ADDENDUM NO. 2

Project Name: 4th Street Culvert Replacement at 90th Avenue (IRC-2022)

Bid Number: 2021045

Plan Sheets 4, 5 and 7 – Addendum 2

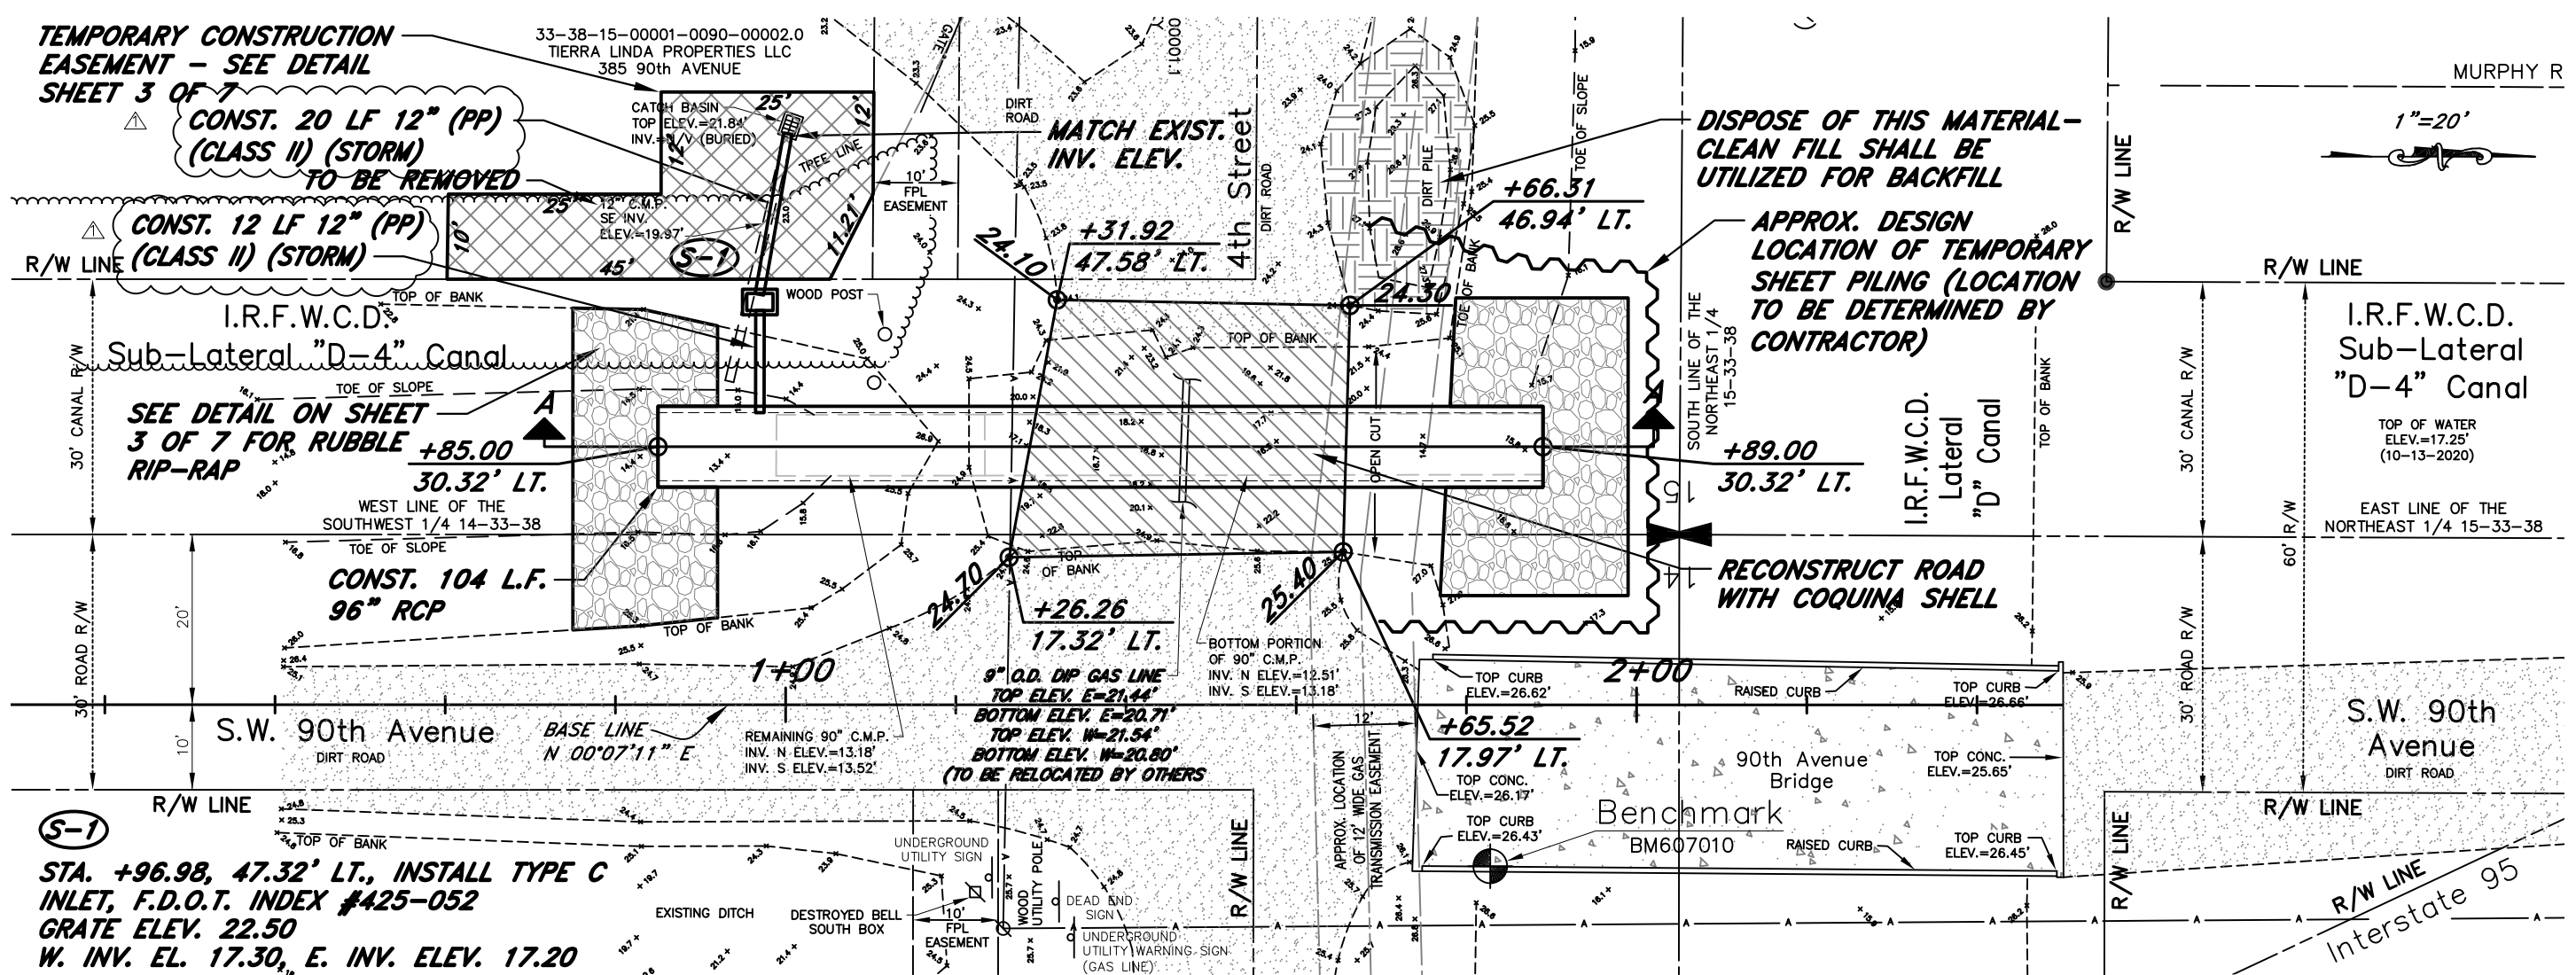
PLAN REVISION SUMMARY	
△	REMOVE PAY ITEM FOOTNOTE 430-175-196, ADD PAY ITEM 108-1 AND PAY ITEM FOOTNOTE 108-1, 5/4/2021, SHEET 4 OF 7 FOR ADDENDUM NO. 2.
△ & △	CHANGE RCP PIPE TO (PP) (CLASS II) (STORM) PIPE, 5/4/2021, SHEETS 4, 5 AND 7 OF 7 FOR ADDENDUM NO. 2.

~~430-175-196 THE BOX CULVERT SHALL BE LAID IN A DRY DITCH, NO DRAIN ROCK SHALL BE ALLOWED UNDER THE PIPE OR IN THE EXCAVATION.~~

108-1 THIS PAY ITEM SHALL INCLUDE ALL INSPECTION, VIBRATION AND SETTLEMENT MONITORING FOR BRIDGE #884016 OVER THE LATERAL D CANAL.

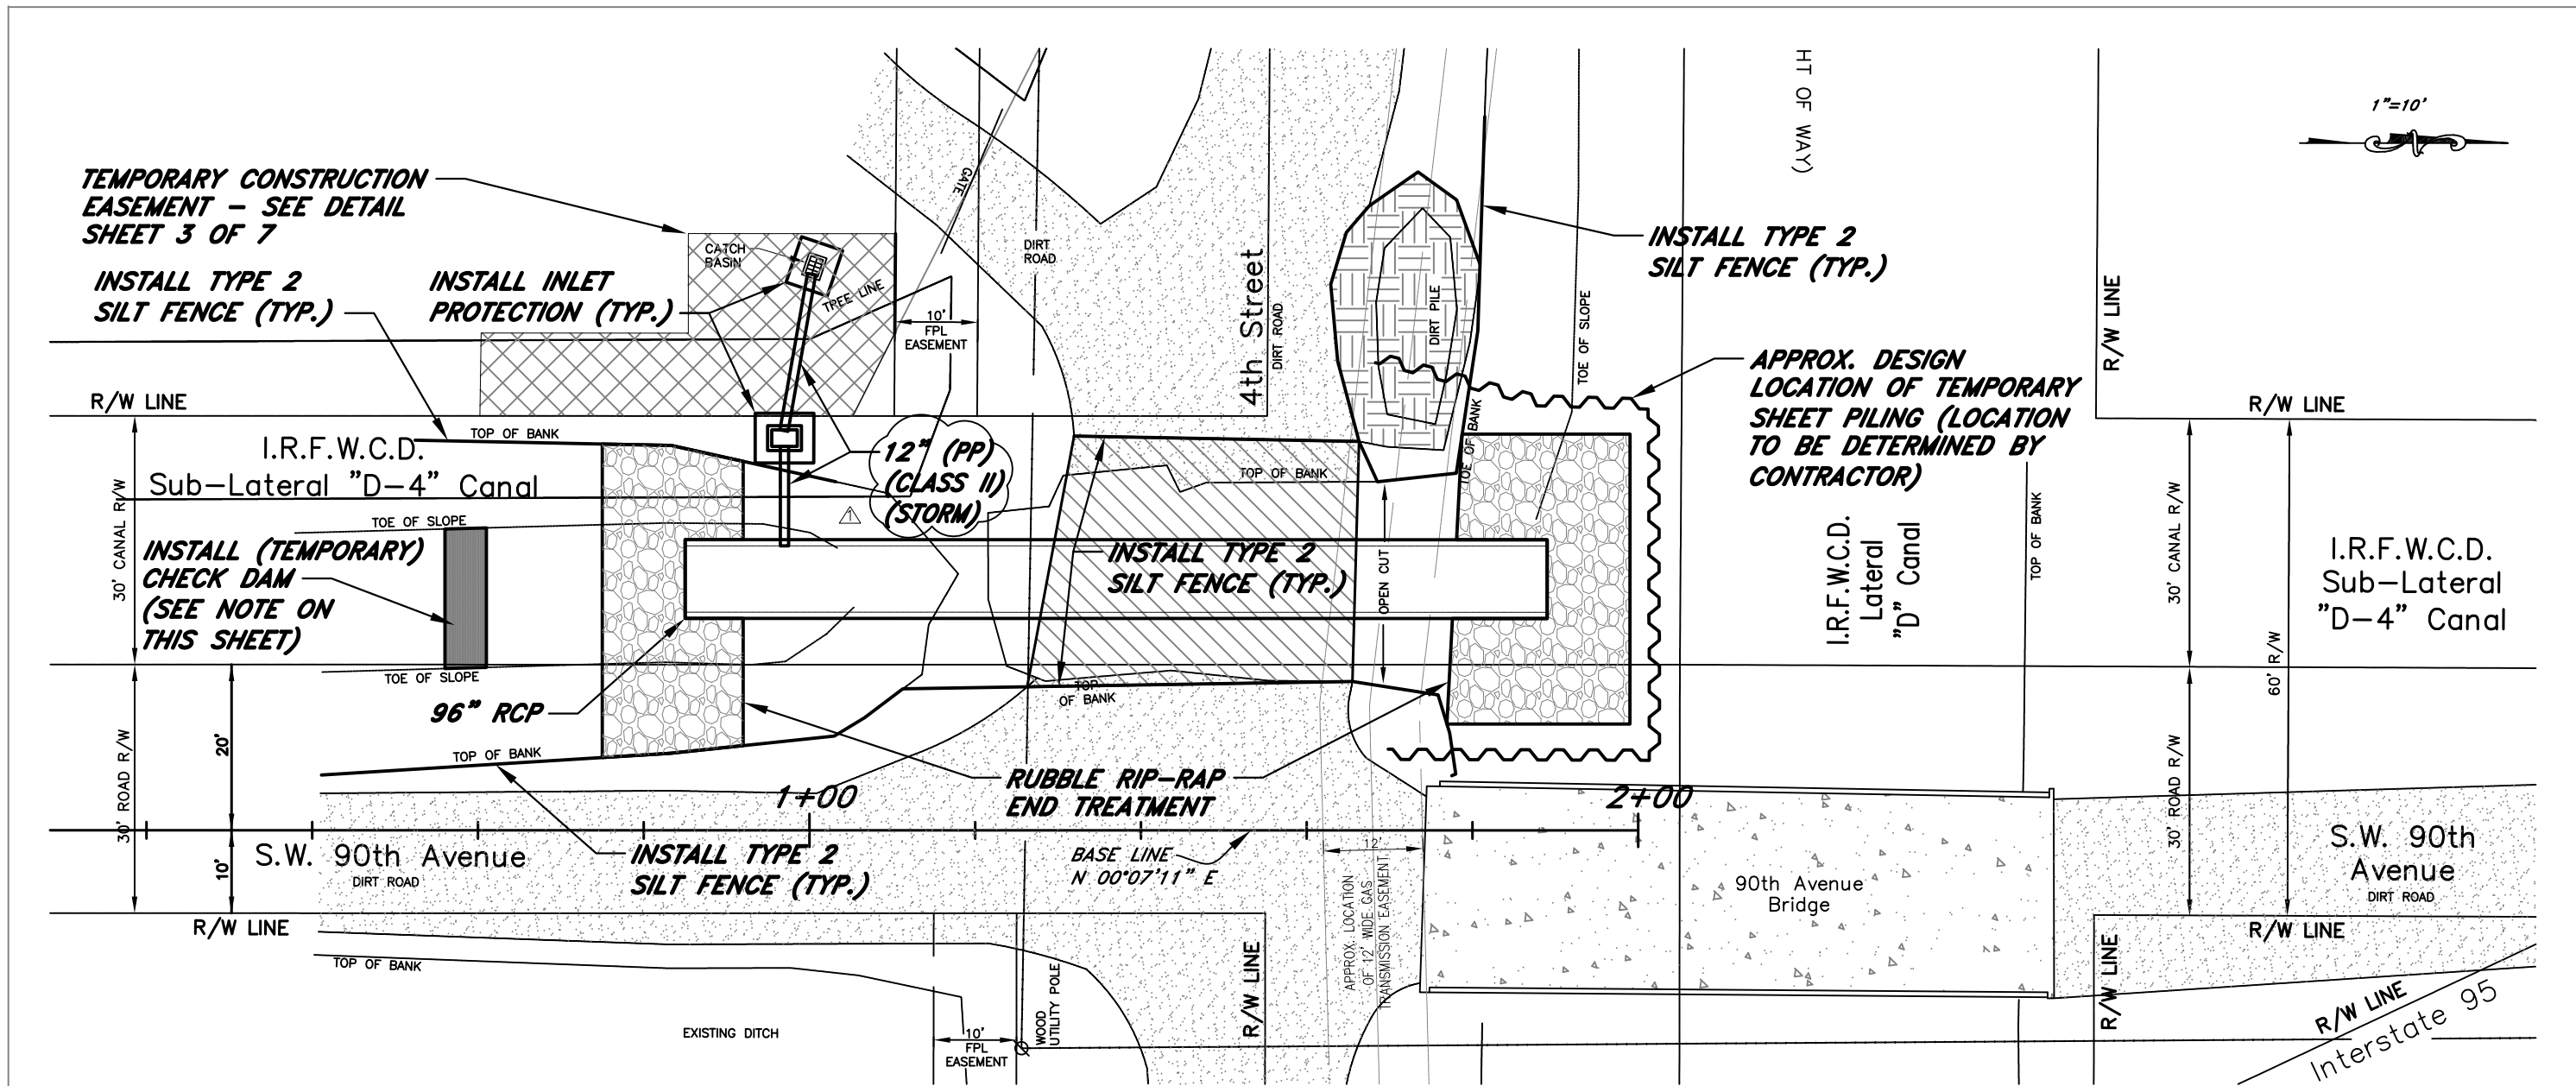
1. For the purposes of ordering our bid bond on this project, do you have a project estimate?
Engineer's Estimate is \$384,005.00.
2. Concrete pipe companies are not making 12" RCP anymore. Should we quote 15" RCP, 12" X 18" Elliptical RCP, or 12" HDPE?
The plans have been updated to reflect the use of 12-inch Class II Polypropylene for the 430-174-112 pay item, as discussed in the pre-bid minutes.
